Access Compliance Report

Public Rights-of-Way

(Curb Ramps)

Intersection ID: 10038352	Main Street: SOUTH_BV	Cross Street: N/A	Location: SE
ADA ID: 9A5D6CE64724	Ramp Type: PerpDiag	Initial Pass/Fail: Fail	Overall Compliance: No
Severity Score: 22.5			
Codes/Mitigation Info/Possible Solution		Field Measurements/Component Compliance

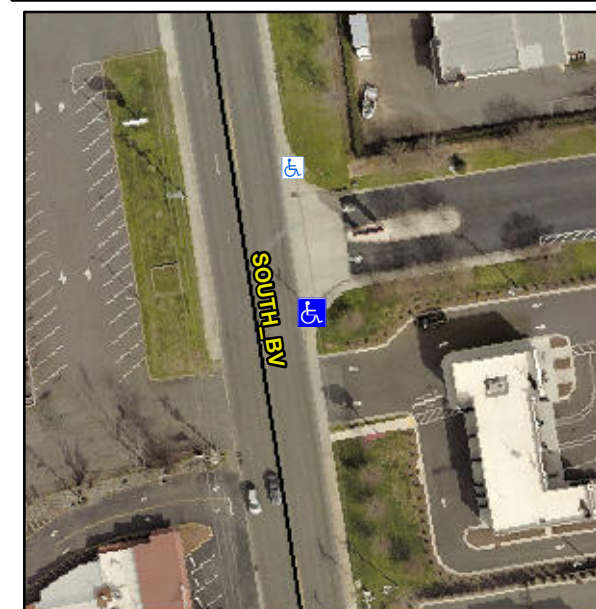
Not Found, R304.5.1, R304.2.2, R304.5.3

Compliance	Description	Data	Compliance	Description	Data
N/A	Ramp Length (in)	51.0	No	Ramp Slope (%)	9.1
No	Ramp Width (in)	38.5	No	Ramp XSlope (%)	2.2
N/A	Flare Type LT	N/A	N/A	Flare Type RT	N/A
N/A	Flare Slope LT (%)	N/A	N/A	Flare Slope RT (%)	N/A
N/A	Flare Traversable LT?	N/A	N/A	Flare Traversable RT?	N/A
N/A	Landing Length (in)	N/A	N/A	DWS Provided?	N/A
N/A	Landing Width (in)	N/A	N/A	DWS Contrast?	N/A
N/A	Landing Slope (%)	N/A	N/A	DWS Length (in)	N/A
N/A	Landing X Slope (%)	N/A	N/A	DWS Full Width?	N/A
N/A	Landing Curb? (Y/N)	N/A	N/A	DWS Offset (in)	N/A
N/A	Shared Landing?	N/A			
N/A	Gutter Ponding?	N/A	N/A	Gutter Slope (%)	N/A
N/A	Gutter Lip Ht (in)	N/A	N/A	Gutter X Slope (%)	N/A
N/A	Painted X Walk1?	No	N/A	Painted X Walk2?	No
	X Walk 1 Direction	To N		X Walk 2 Direction	To W
N/A	X Walk 1 Width (in)	N/A	N/A	X Walk 2 Width (in)	N/A
	X Walk 1 Slope (%)	1.9		X Walk 2 Slope (%)	3.7
	X Walk 1 X Slope (%)	2.0		X Walk 2 X Slope (%)	3.3

Remove & Replace Curb Ramp With Two New Directional Ramps or Equivalent.
